M O D I F I C A T I O N S

COMMUNICATIONS RECEIVER

MODEL GPR-90

TMC SPECIFICATION NO. S -10006-E

No 1

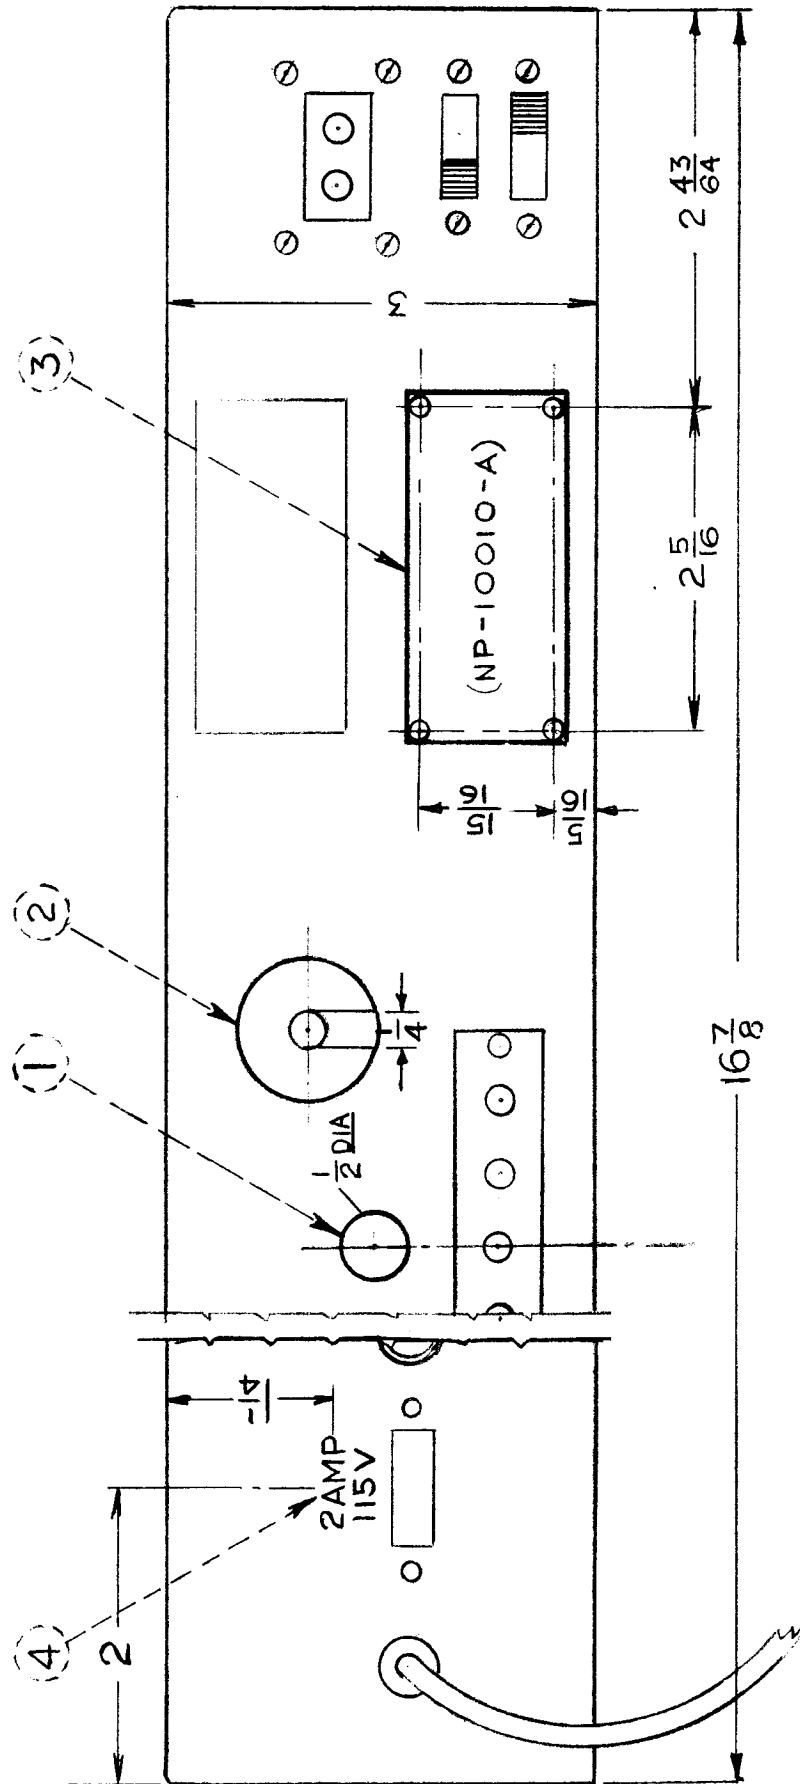
Position and drill 3 Holes to suit screws SC-110-1. See detail drawing No. 1. Mount the nameplate.

Position stamp as detailed in drawing No. 1, and mark chassis using suitable black ink.

Position and mount snap hole plugs in accordance with drawing No. 1.

DRNG. NO 2

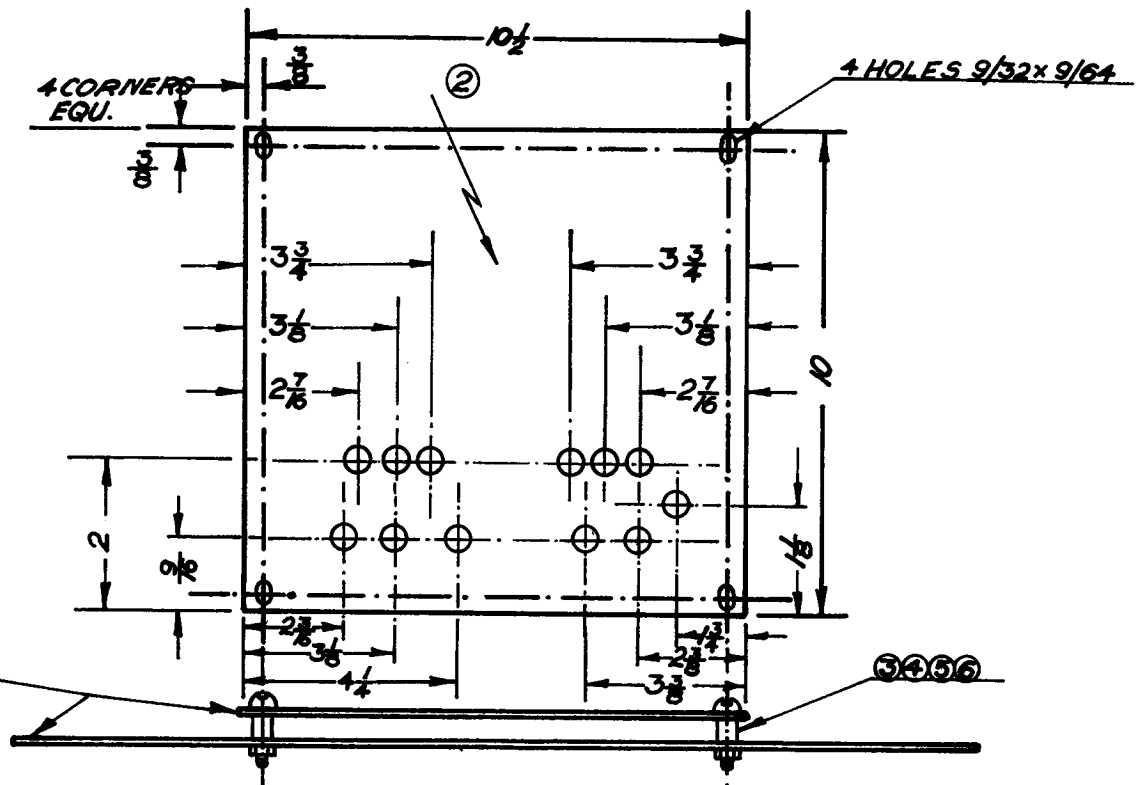
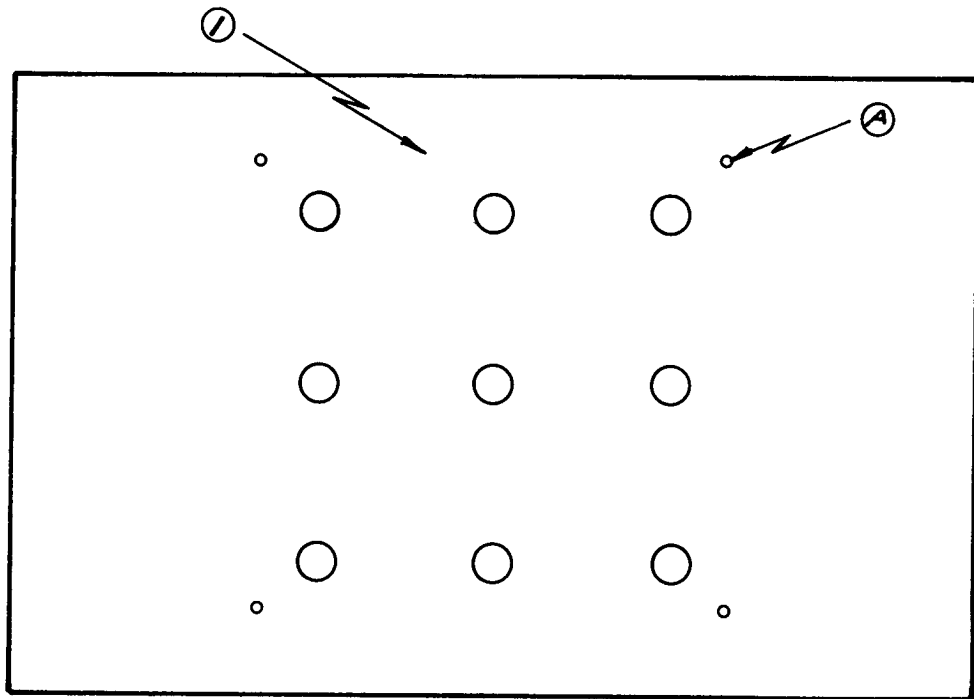
4. Drill the 10 $\frac{1}{2}$ " x 10" plate 4 holes, 4-40 clearance, as detailed in drawing No. 2. Position plate on centre line of case, with 10 $\frac{1}{2}$ " side parallel to the rear side and 1 $\frac{1}{2}$ " from it. Use plate as template and drill 4 mounting holes in case, and six 9/16" access holes in line. Remove all burrs, etch and irridite plate and assemble in case (See drawing No. 2)

NOTE: 'A' MOUNTING HOLES FOR SECURITY PLATE TO BE DRILLED AFTER ALIGNING ADJUSTMENT HOLES IN SECURITY PLATE AND CABINET
